**RE: Information Request Response  
Thunder Butte Pipeline Project, Case No. PU-24-086**

## REQUESTS FOR INFORMATION/QUESTIONS AND TBPL'S RESPONSES

### Existing Pipeline Depth of Cover Summary

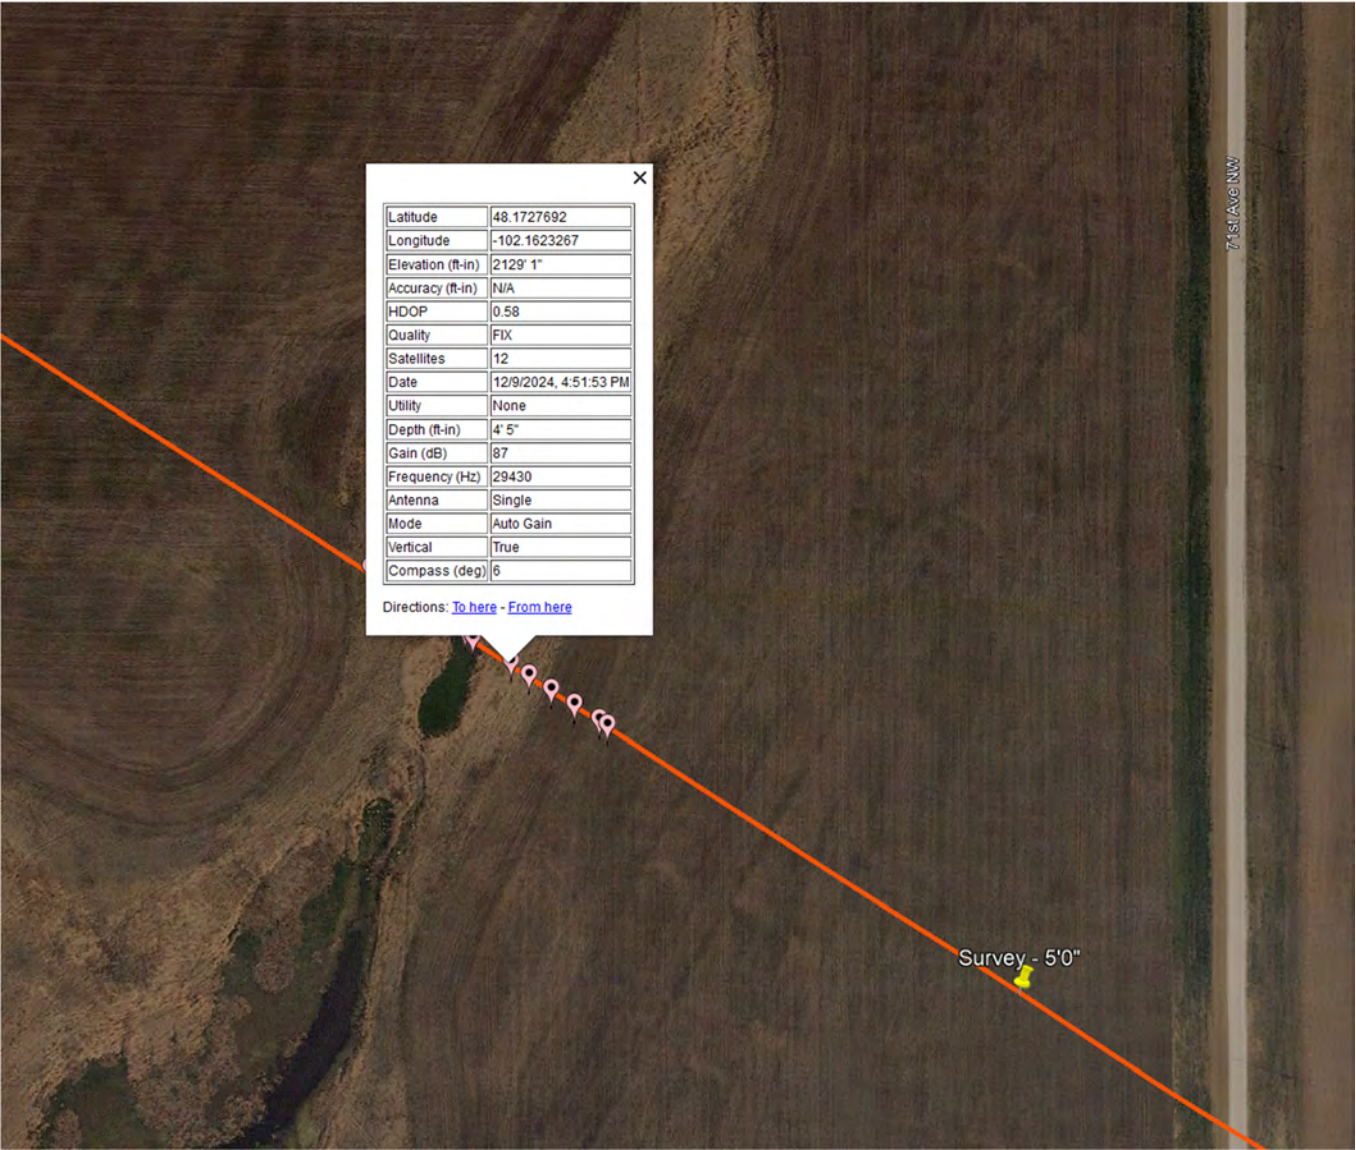
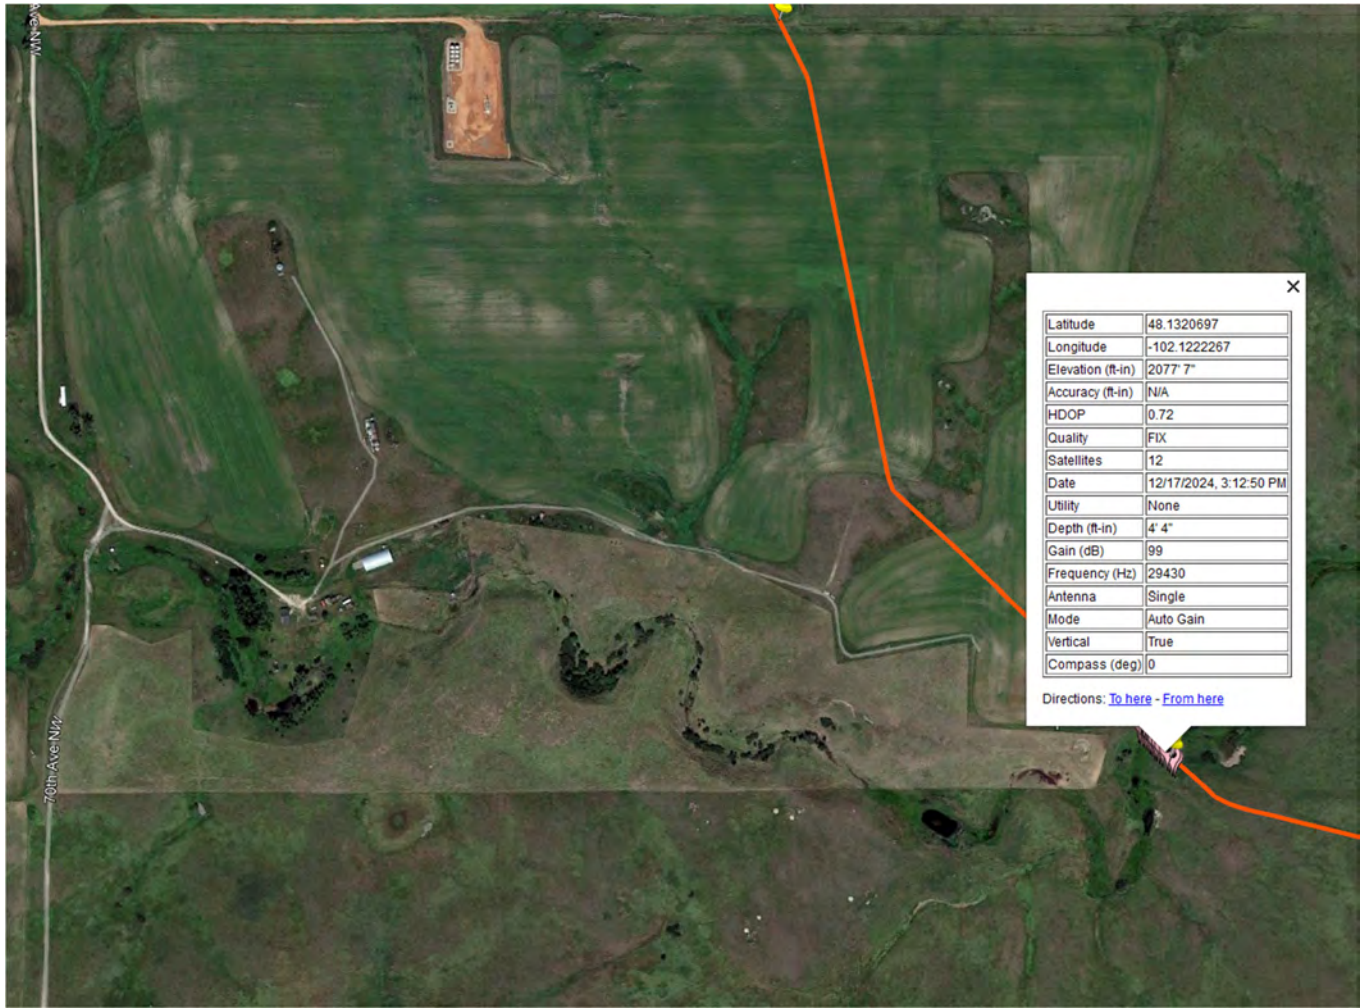
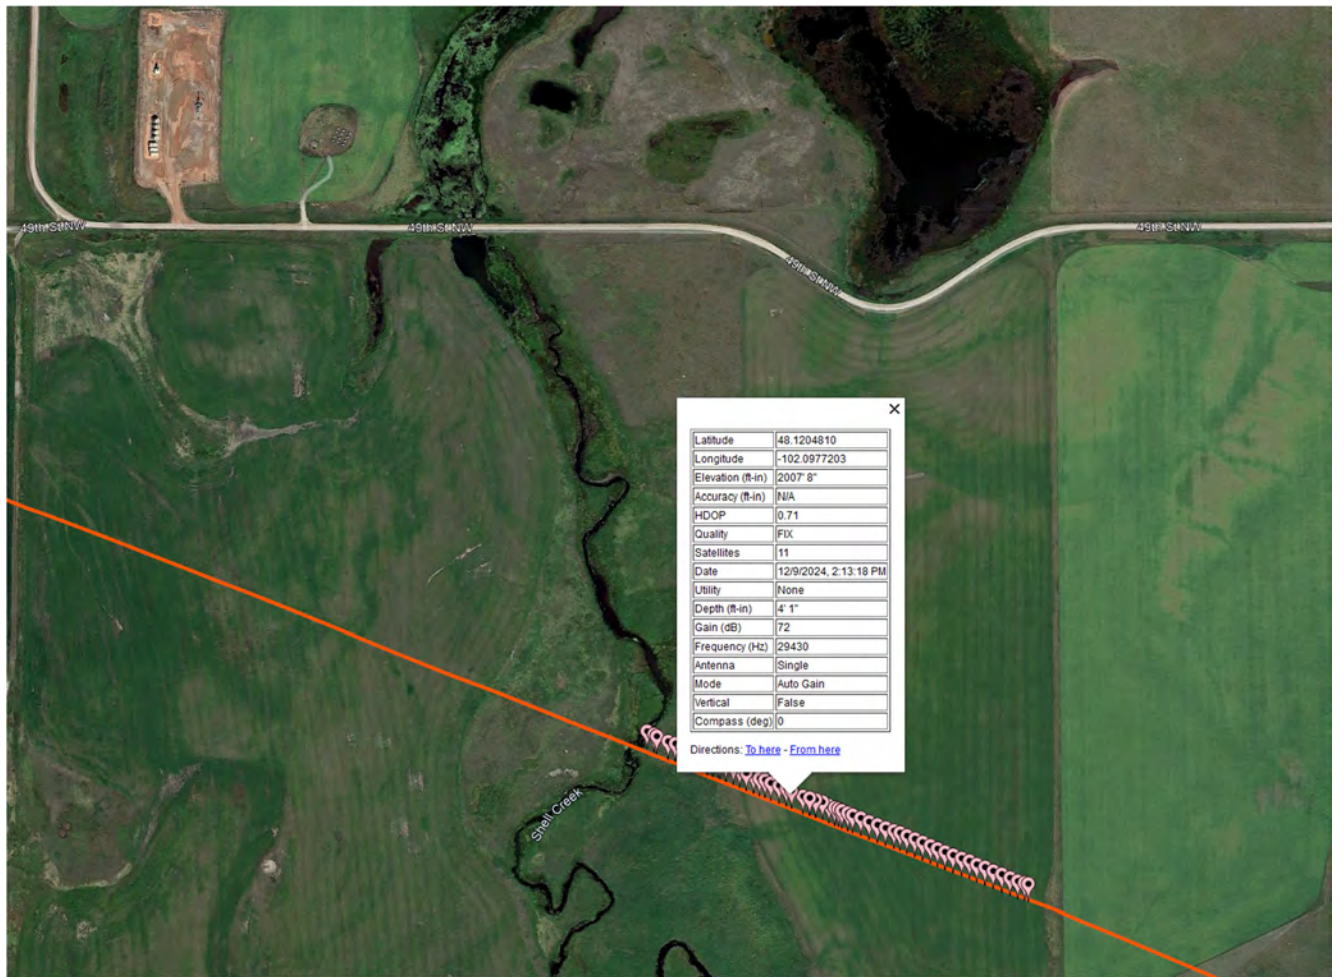
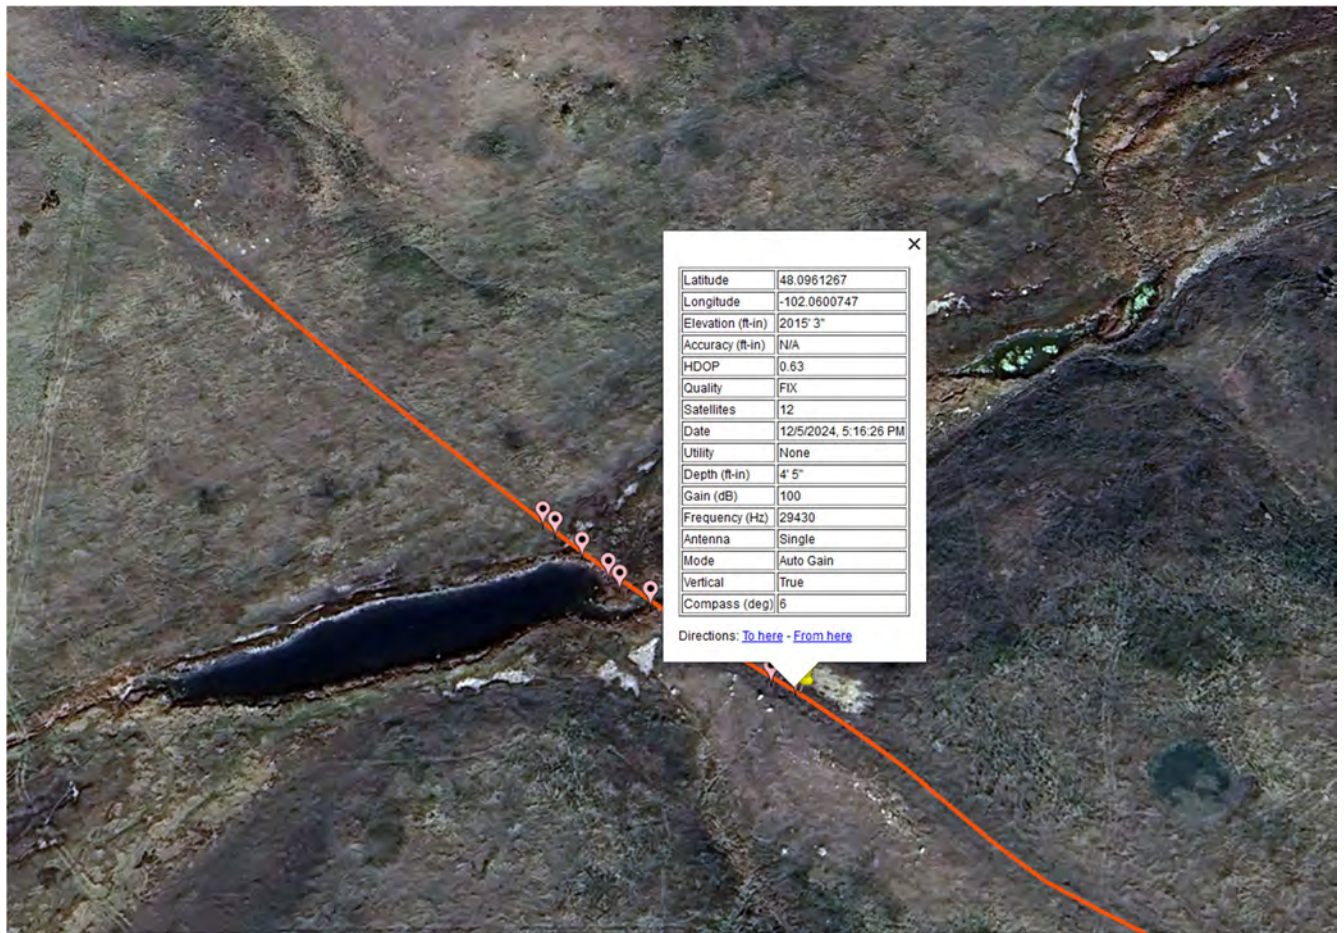
10. Please provide a map set and table showing the locations of all DOC measurements that are less than 48", mileposts, all locations/features studied in the tables to the GI, and jurisdictional and non-jurisdictional wetlands and waterbodies. **A qualified contractor recently conducted an updated DOC analysis for the areas along the line that were of concern using GPS line locating and depth equipment. None of the DOC measurements for the existing pipeline were less than 48". The new pipeline will be installed with a minimum DOC of 72" across the entire route. A table of all the DOC measurements and a map set showing the locations of all DOC measurements are provided in **Attachment 1**.**

15. Provide all DOC measurements with locations that the company performed. For instance, the GI indicates that DOC measurements for all areas of concern were taken at locations that may not have been provided in the summary showing the GPS locations. Please also include those locations mentioned in the summary table, and supplement the table with milepost locations, and Feature IDs that correspond to the GI (if applicable). Please disregard the DOC estimates in the GI Report. These DOC estimates are incorrect. A qualified contractor recently conducted a new DOC analysis for the areas of concern using GPS line locating and depth equipment. None of the DOC measurements for the existing pipeline were less than 48”. A table of all the DOC measurements and a map set showing the locations of all DOC measurements are provided in **Attachment 1**.

Depth of cover determined using GPS line locating and depth equipment. Please see attached screenshots of survey locations.

**NOTE:** The entire pipeline will also be shot by survey during construction of the new line to determine a depth of cover for the entire pipeline. Any areas found to be less than 48" depth of cover will be investigated further and mitigated properly to obtain the minimum depth of cover required.
